AIRWORTHINESS DIRECTIVE

Number: CAA-AD-076/2003

APPLIANCE – PILOT RESCUE PARACHUTE – RIPCORDER PIN - INSPECTION

MANDATORY SERVICE BULLETIN No. M ATL-01a

foto č. 1

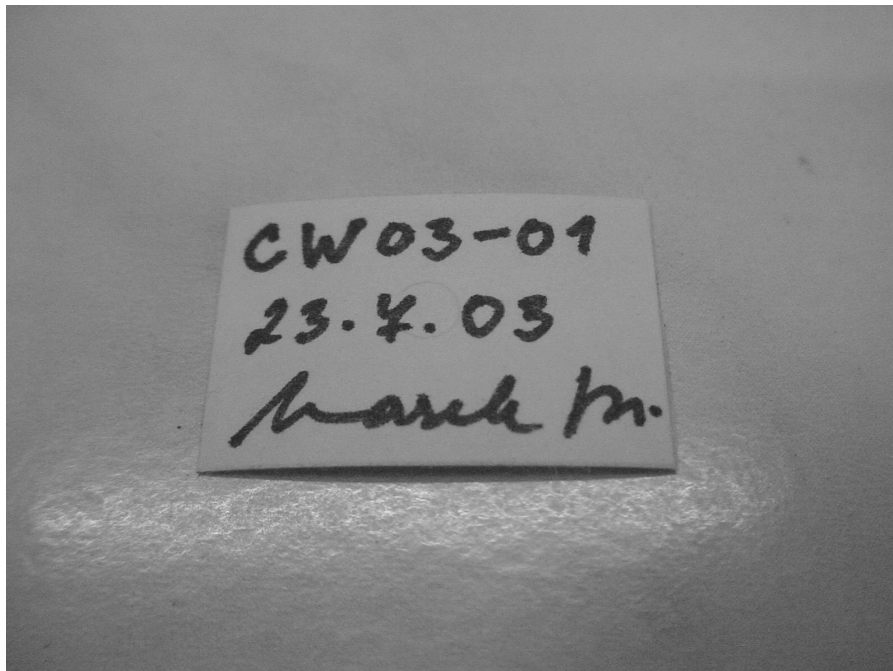
- b) The handle of the release device must be marked CW 03-01, alternatively including date and signature.

We recommend the marking the handle with a self-adhesive plate with required inscriptions; if need be, the plate can be stuck all over with a transparent adhesive tape attached up to the area that has minimal resistance to abrasion and that is visible even when the release is hidden in a pocket. In emergency, the release can be marked with a permanent highlighter/marker.
